SPARC Enterprise T5140 and T5240 Servers Product Notes

4. Documentation Errata 47

FIGURE 4-1 Minimum Clearance for Service Access

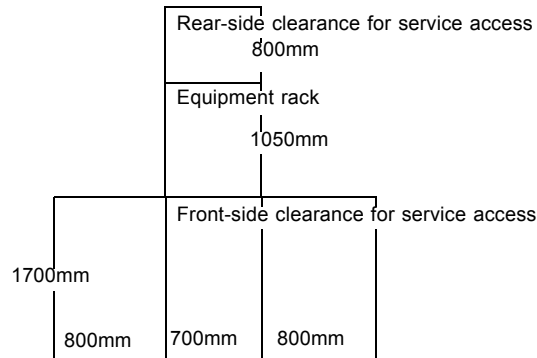
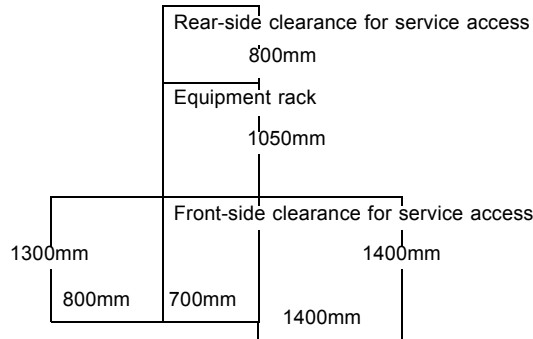
The SPARC Enterprise T5140 and T5240 servers require physical access from the top for maintenance. Therefore, a stepladder may be required depending on which rack the server is installed in. And it may be necessary to remove the server from the rack depending on the component to be replaced.

No stepladder is required if this server is installed at the 20U level or lower. A stepladder is required if it is installed at the 21U level or higher. [FIGURE 4-1](#) shows the minimum clearance for service access required for either server.

1. If the server is installed at the 20U level or lower (*1): (*1 Judged based on the level of the equipment top)

2. If the server is installed at a level between 21U and 40U (*1): (*1 Judged based on the level of the equipment top)

FIGURE 4-1 Internal Cables for the Onboard SAS Controller Card (Four-Disk Capable SPARC Enterprise T5140 Servers)

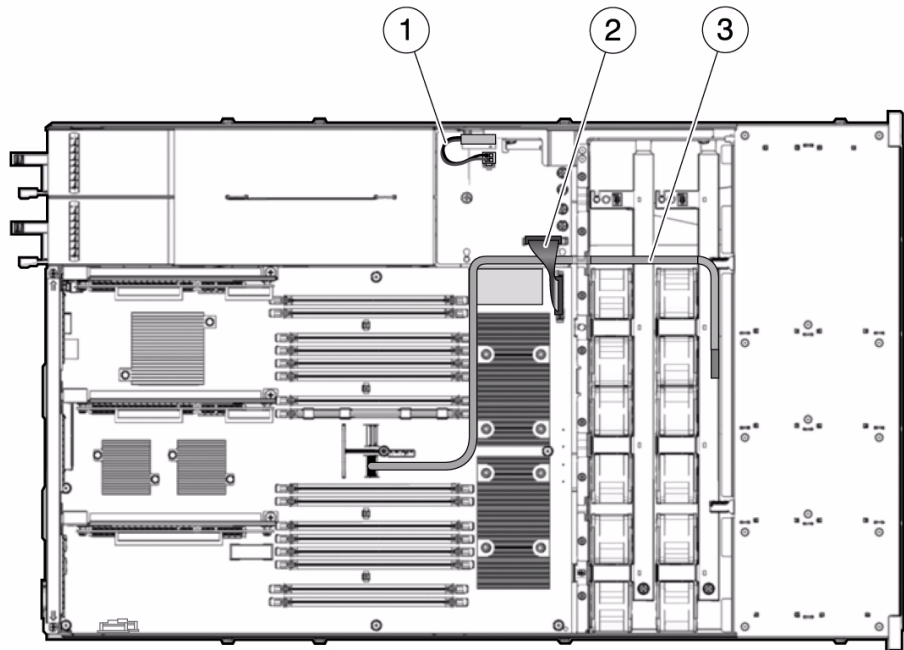
Incorrect Data Cable Routing Diagram for T5140 Servers With 4-Disk Backplanes

The data cable routing diagram for 4-disk capable backplanes is wrong. It shows the cable connected to SAS1. It should be connected to SAS0. This is the correct diagram:

FIGURE 4-2 Internal Cables for Onboard SAS Controller Cards (Eight-Disk Capable SPARC Enterprise T5240 Servers)

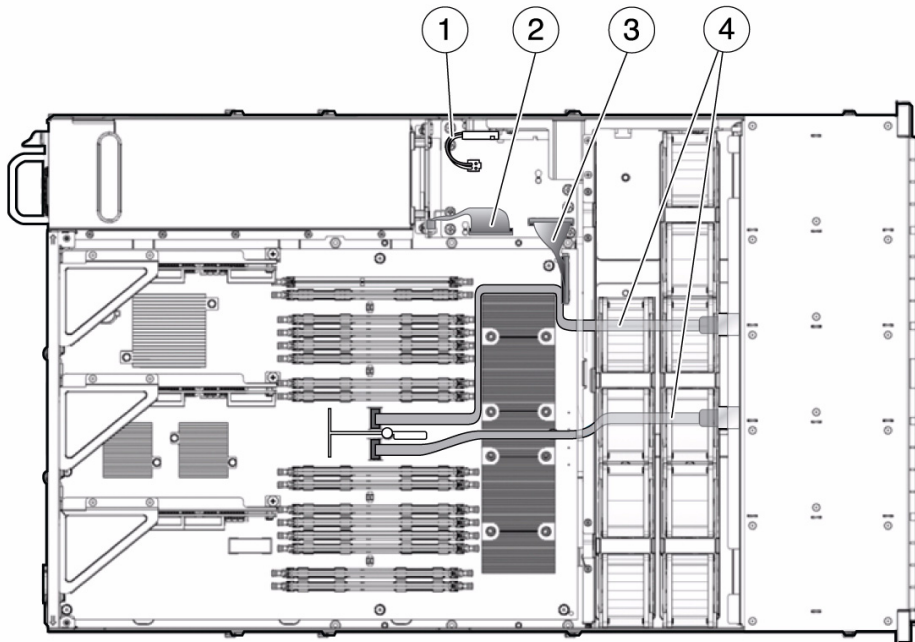
Incorrect Data Cable Routing Diagram for T5240 Servers With 8-Disk Backplanes

The data cable routing diagram for 8-disk capable backplanes in T5240 servers is wrong. It shows a single data cable. There should be two. This is the correct diagram:

FIGURE 4-3 Internal Cables for the Onboard SAS Controller Card (Eight-Disk Capable SPARC Enterprise T5140 Servers)

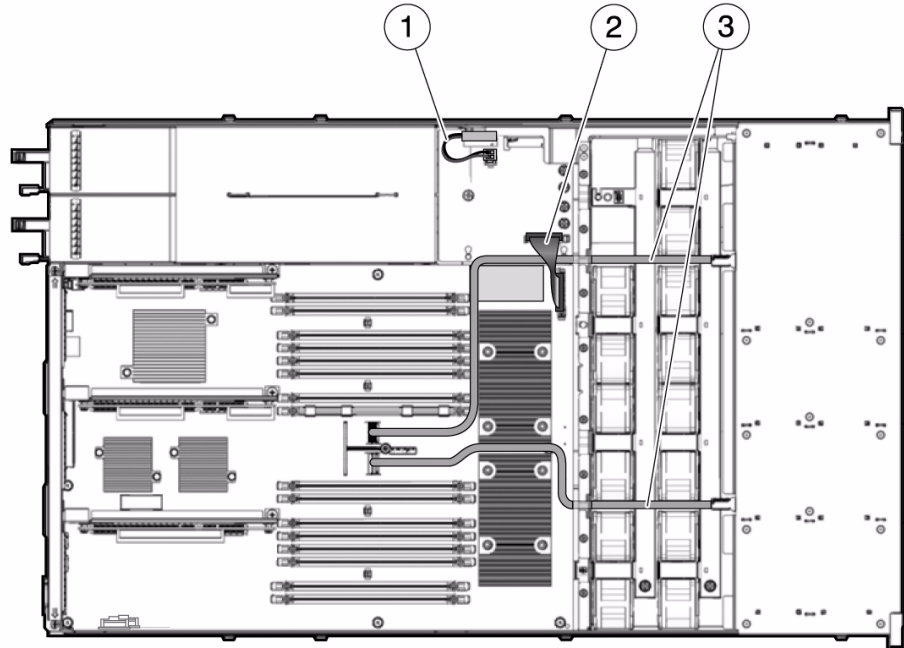
Fan Module Missing in Data Cable Routing Diagram

The cable routing diagram for 8-disk capable backplanes in T5140 systems is missing a fan module in the upper right corner. This is the correct diagram:
